## **Flawed Analysis is Producing Inaccurate Base Flood Elevation Maps in Skagit County**

Background Paper prepared for the U.S. Chamber of Commerce July 13, 2007

**Corps flood frequency dataset showing unmodified Concrete estimates and 58 years of gage data**

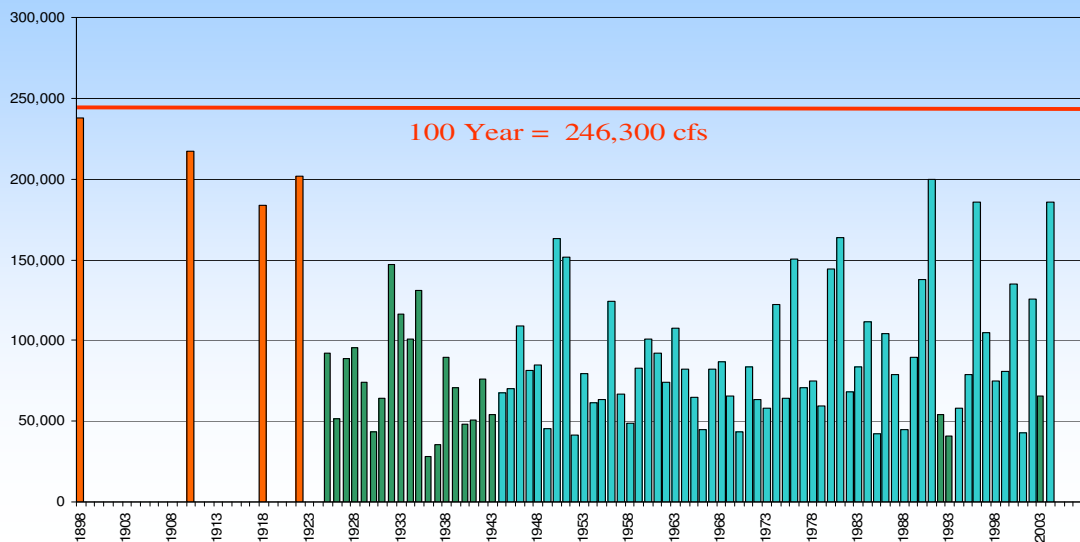
- b) The Corps hydrologic analysis is wrong, resulting in a hydraulic model that is wrong.
    - i) Corps hydrologic analysis relies on estimates of the magnitude of floods occurring near the turn of the 19<sup>th</sup> century, prior to the 1924 installation of a river gage near the town of Concrete, WA.

- ii) Comparing 80 years of actual gage data to the historic estimates clearly indicates the historic estimates are skewed high.
    - iii) This concern with the historic estimates has long been recognized by experts. Additional analyses conducted over the past 5 years have provided technically substantial, compelling, and defensible new information clearly indicating the historic estimates used in the flood frequency analysis should be reduced.

- c) The Corps so far has declined requests to revise the historic estimates, and continues to use the unmodified estimates in its analysis. Therefore, the Corps hydrology and hydraulic model significantly over-estimate the magnitude of a Skagit River 100-Year flood.

**PI Engineering flood frequency dataset showing modified Concrete historic estimates and 80 years of gage data**

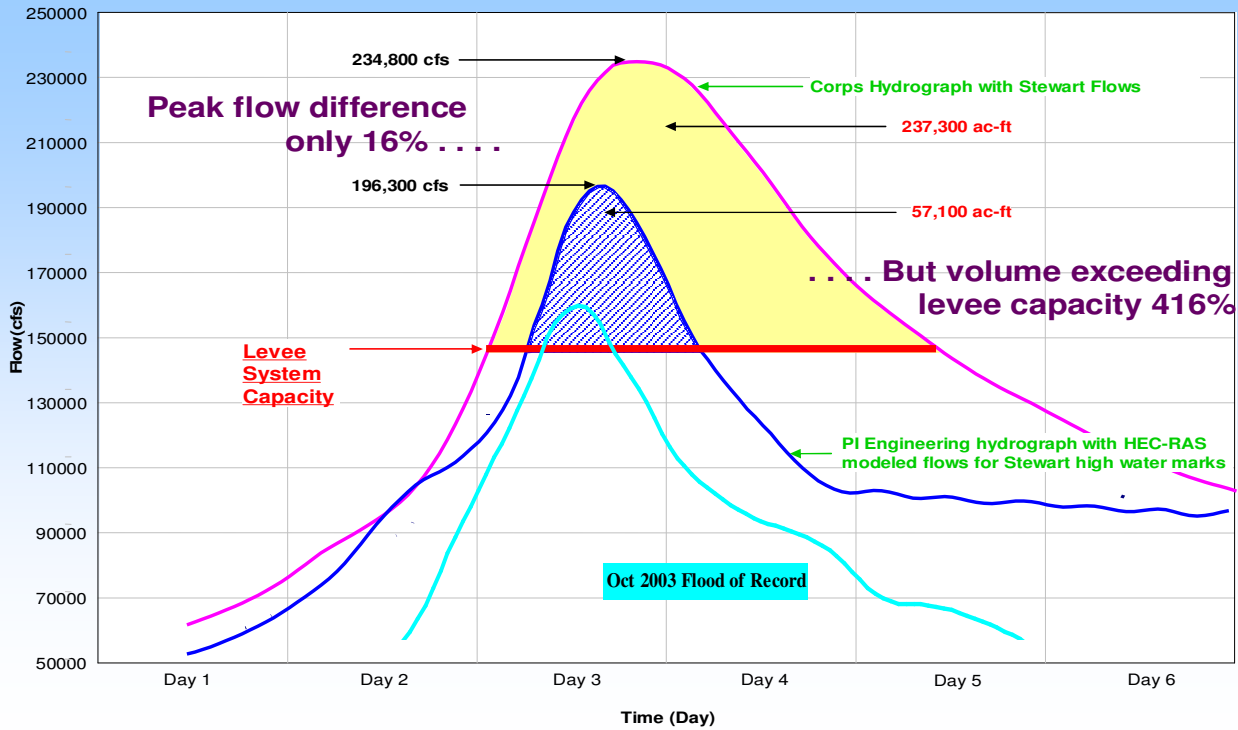
2. Technical analysis of the Concrete reach conducted by PI Engineering, 2005 pointing out:
  - a. Stewart flows could not have exceeded 202,000 cubic feet per second without overflowing the river banks at the Dalles. But Stewart, pursuant to in-depth on-site study shortly after the 1921 flood, said no overflow happened. So the peak flow then could not have been 240,000 cfs, as is currently shown in the USGS data for that station

- b. Further analysis conducted by PI Engineering indicated the maximum discharge from the historic floods that would not have exceeded the 1995 event would have been 188,000 cubic feet per second

Nhc-inferred flood frequency dataset including reduced Sedro-Woolley 1897 and 1909 historic estimates, an increased 1932 estimate, and including the 2006 unregulated flood peak estimate

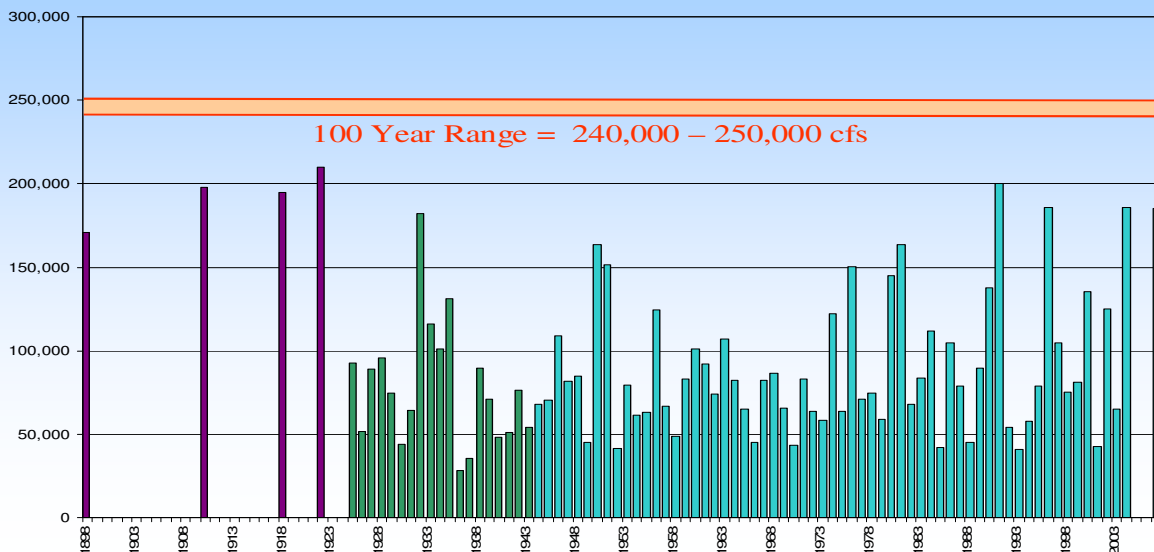
3. Independent technical review conducted by Northwest Hydraulic Consultants (**nhc**), 2007
  - a. In-channel storage sufficient to attenuate flows between Concrete and Sedro-Woolley does not exist. Therefore, either the Concrete estimates are too high, or the Sedro-Woolley estimates are too low. But **nhc** stated that nothing in the record indicates the Sedro-Woolley estimates are too low – in fact, the 1897 and 1909 estimates should be further reduced

- b. The use of a methodology called “Expected Moments Algorithm” would indicate an unregulated peak flow estimate similar to that calculated by PI Engineering
